RE: INDIAN POND PROJECT, FERC NO. 2142
STUDY PLANS FOR FISHERIES ENHANCEMENTS

RE: Indian Pond Project, FERC No. 2142
Review of Draft Study Plans as Required by Article 401 and Sections 3.3.3.C,
3.3.5 and 3.3.7 of the Indian Pond Settlement Agreement

Fish Habitat/Fish Population Assessment Study Plan

Study Plan for Field Evaluation

Figure 20. Aerial photograph of Cold Stream at CS1, old dam site near its junction with Tomhegan Stream. Section of channel between the two dotted lines is where detailed field studies for channel modification and habitat enhancement measures are proposed.

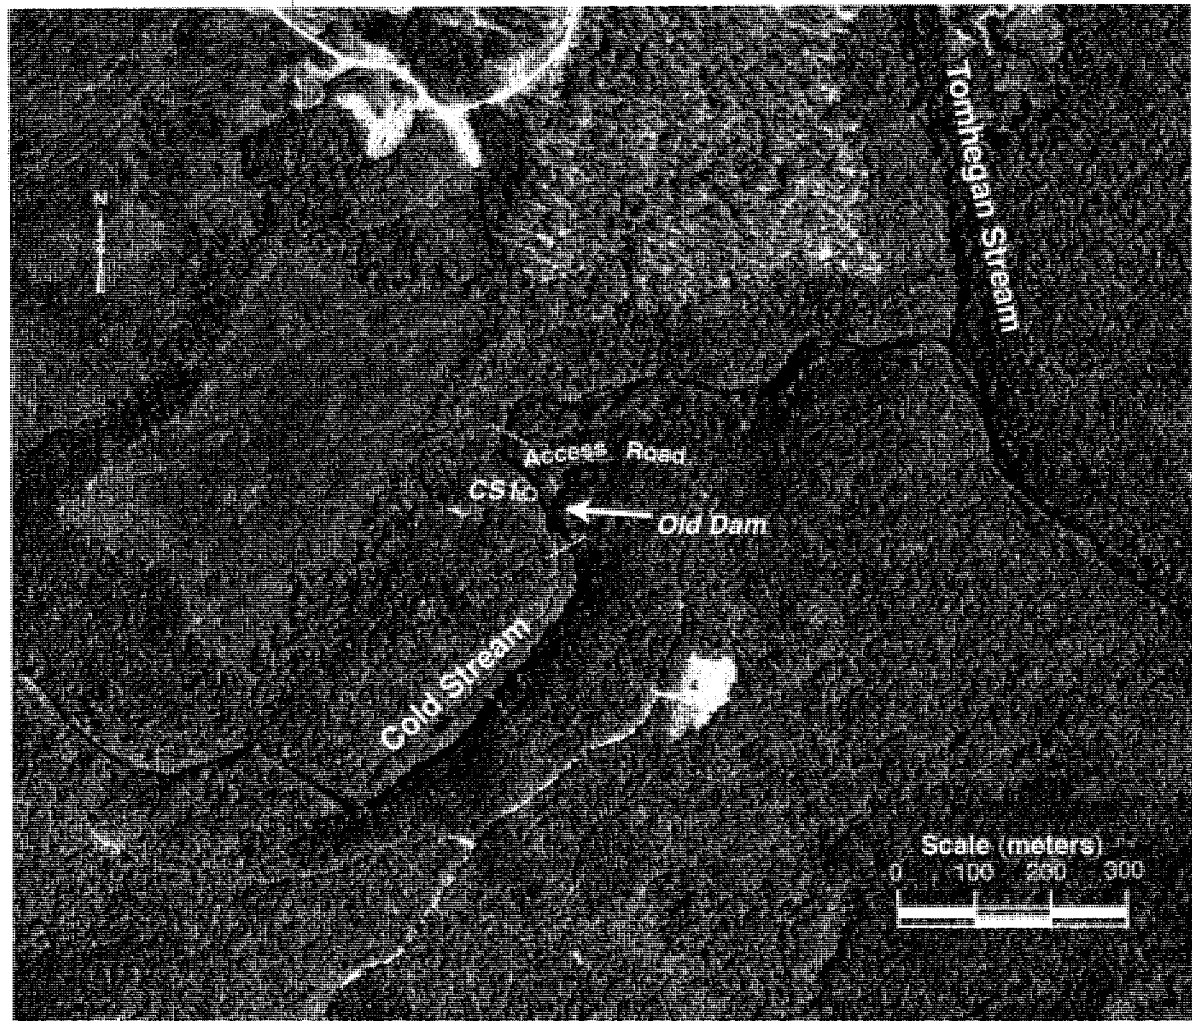
We agree with the recommendation in the field evaluation to move forward with the necessary planning for a restoration project on Cold Stream and one for the East Branch

of Enchanted Stream. The Cold Stream restoration area is located at a former dam site. The current channel is a long glide, lacking significant structure. The Enchanted Stream restoration area is located near a recent channel avulsion, which has likely caused the left bank to erode.

Post-project monitoring should be conducted for three consecutive years to evaluate the success of each project. The monitoring studies should include an assessment of the stream morphology; hydrology; and aquatic habitat and fish population. A coordination meeting should occur at the end of the monitoring period to evaluate the monitoring results and to decide on the effectiveness of the project.

We recommend a coordination meeting after the pre-project monitoring and feasibility study is completed on each project. The purpose of the meeting would be to review the design options and to decide on the types of structures that are appropriate at each site.

Figure 21. Aerial photograph of East Branch of Stream (ES3), near its junction with Enchanted Stream downstream of Enchanted Pond. Section of channel between the two dotted lines is where detailed field studies for channel modification and habitat enhancement measures are proposed.

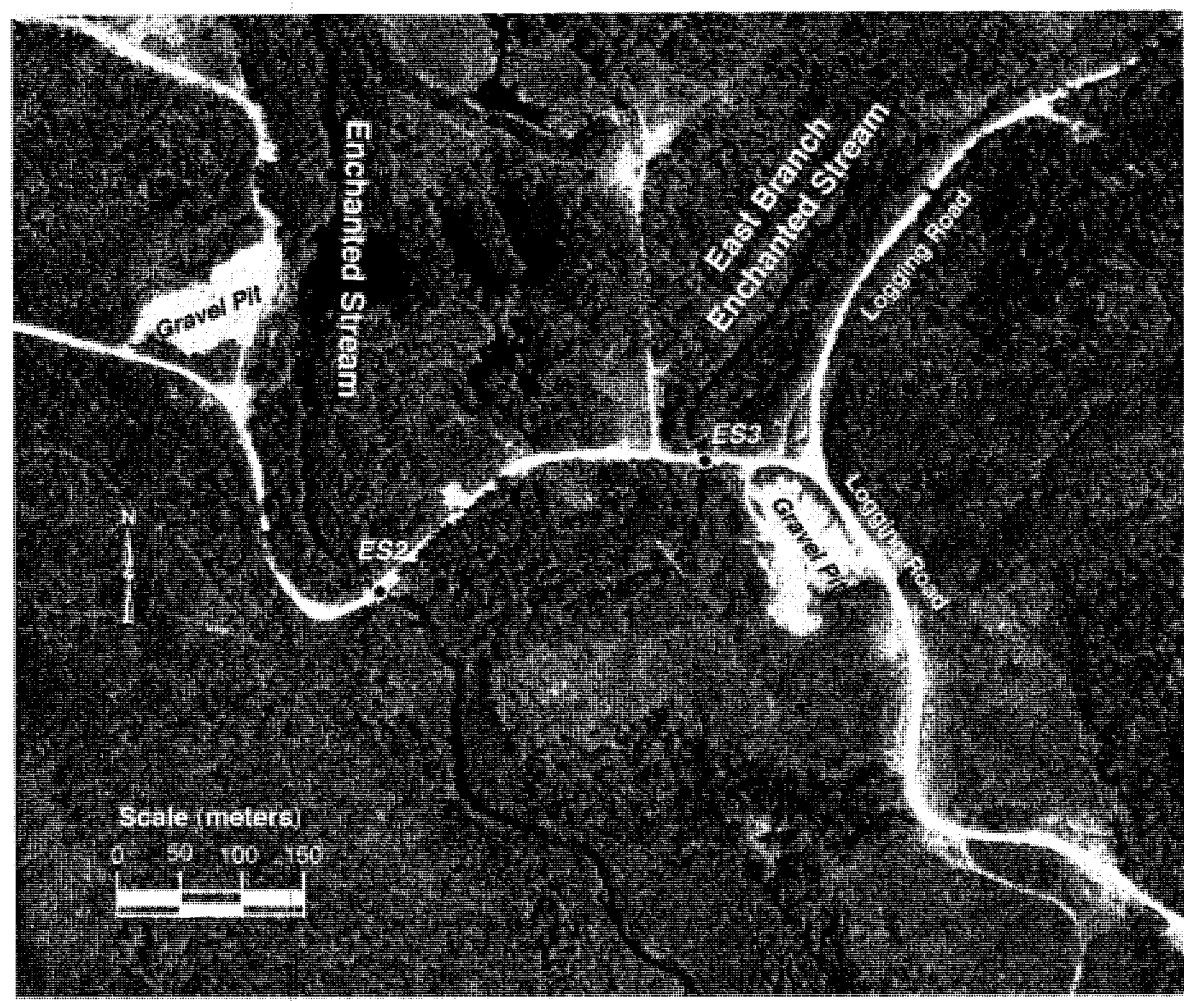
The stream morphology and hydrologic studies should carefully evaluate the stability of Enchanted Stream because of the recent evidence of a channel avulsion. The stream channel may be adjusting as a result of this avulsion so addressing the bank erosion may only cause further erosion downstream.
